1963 Corvette: Service Bulletin: Interim Production Changes

Source: Chevrolet Technical Service Bulletin

Bulletin No: DR #569

Date: December 31, 1962

FIGURE 1

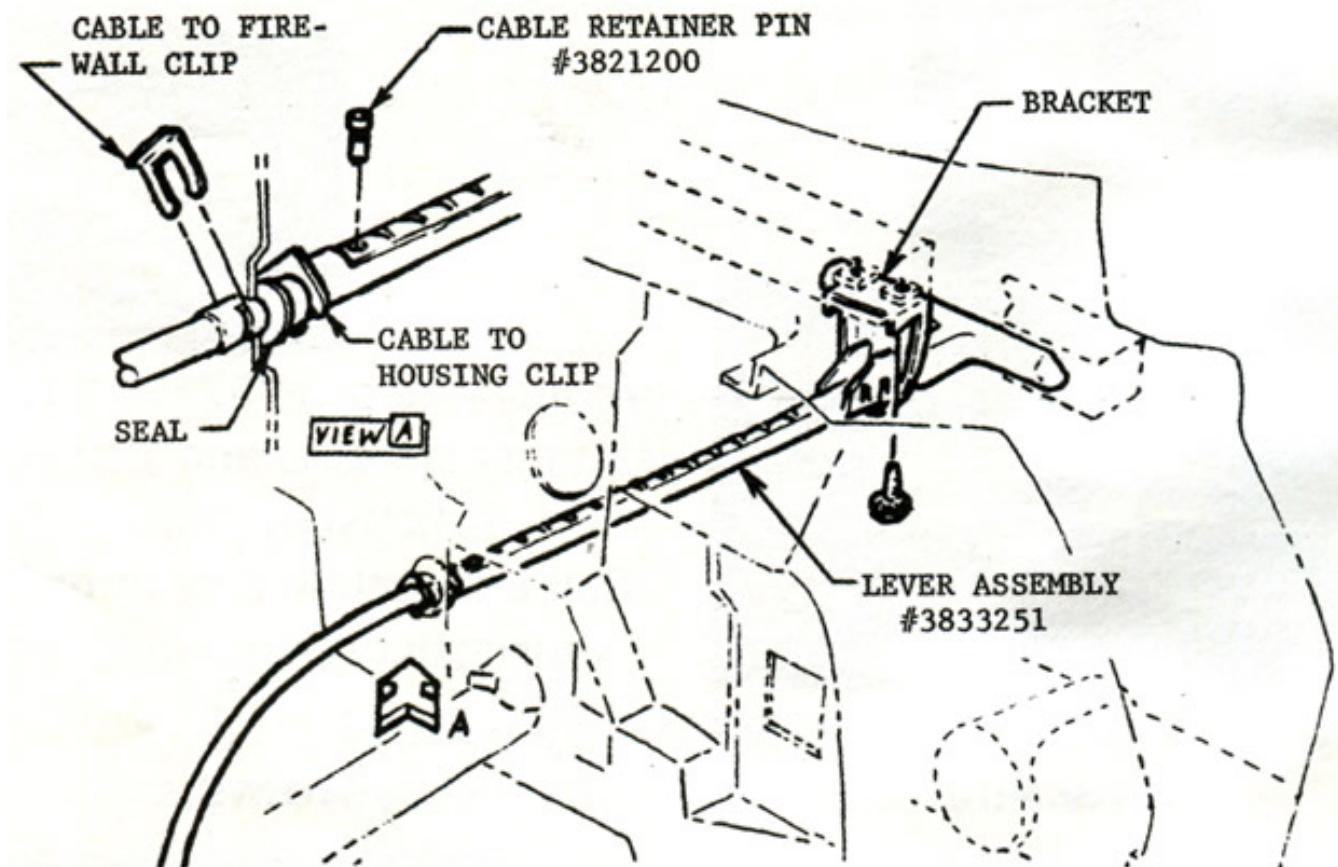
1. Effective with Serial No. S101893, a redesigned parking brake lever assembly entered Production. Early vehicles incorporate a lever assembly which may be difficult to release and in extreme cases, may actually jam making release impossible.
2. Vehicles with Serial No. S101847 through S102667, were built with a second design rear axle driveshaft flange that may not seat properly in the rear wheel drive spindle flange. An interference condition at this location could possibly lead to early failure of the rear wheel spindle flange attaching bolt bosses.

Lever Assembly should be replaced on all vehicles built prior to Serial No. S101893. Referring to Figure 1, proceed as follows:

1. Scrape sealer away from cable to firewall clip and remove clip.
2. Disconnect parking brake cable clip from steering gear retainer bolt.
3. Disconnect oil pressure line at gauge and pull line out of parking brake lever assembly bracket.
4. Remove two (2) bolts holding bracket to dash brace.
5. Pull complete lever and cable assembly to the rear, far enough to remove parking brake signal switch.
6. With handle all the way in, cable retainer pin will line up with hole in bottom of housing allowing pin to be driven out from bottom with a punch.
7. Remove cable to housing clip and separate cable from housing.
8. Install original seal on new lever assembly No. 3833251.
9. Reassemble by reversing the above steps using new cable retainer pin No. 3821200. NOTE: Chamfered side of pin must face forward to

actuate the parking brake signal switch properly.

10. Apply body sealer around cable at firewall to prevent water leaks.

FIGURE 3 - DRIVESHAFT FLANGE

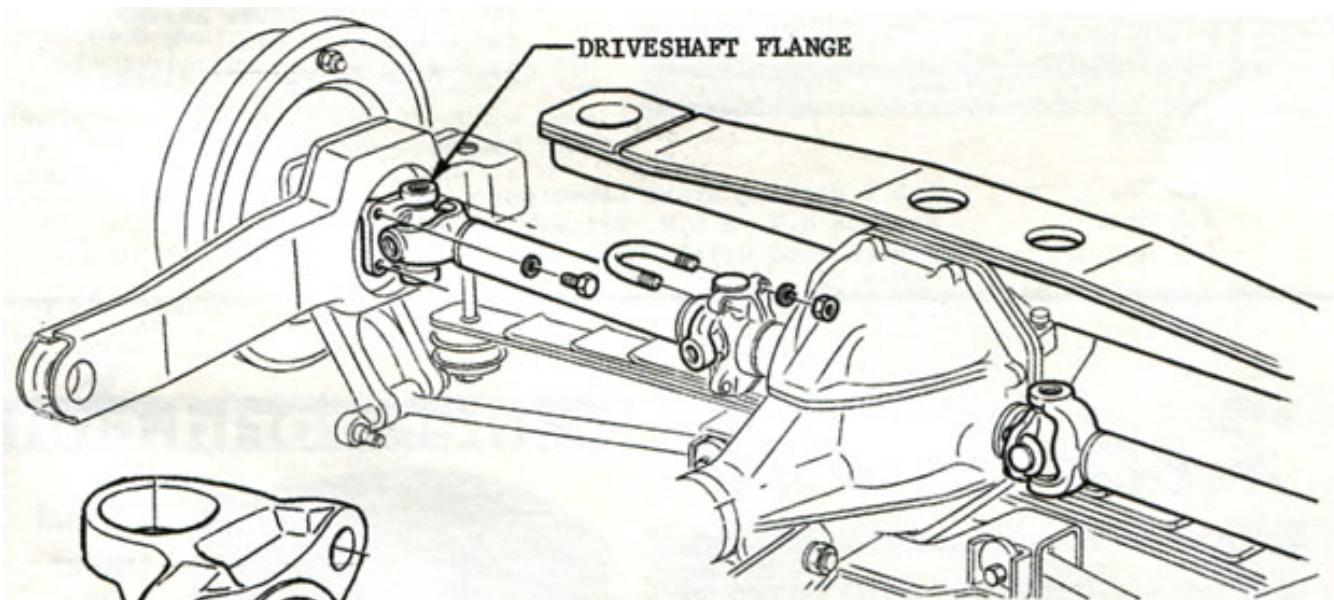
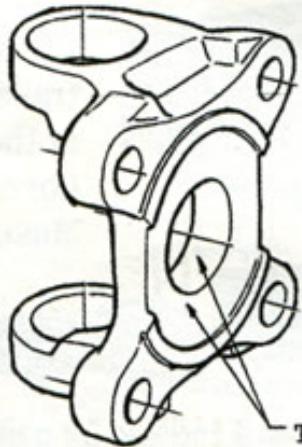
New machined Driveshaft Flanges No. 3832048, should be installed on all vehicles with Serial No. S101847 through S102667 (Ref. Figs. 2 and 3).

Replacement of the driveshaft flange is covered in the 1963 Corvette Shop Manual, Page 4-16. The rear wheel spindle flange attaching bolt bosses should be visually inspected while the axle driveshafts are out of the vehicle. Replace with new Spindle Flange Assembly No. 3830253 if any cracks are evident in the area indicated in Figure 4.

FIGURE 4 - SPINDLE FLANGE

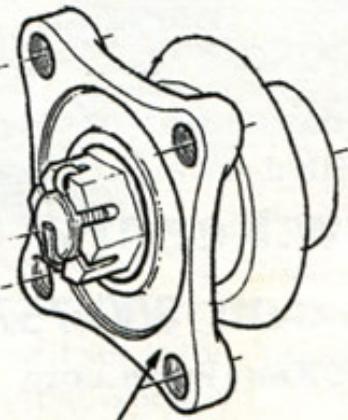
CHECK ALL FOUR
BOSSES FOR CRACKS
IN THIS AREA
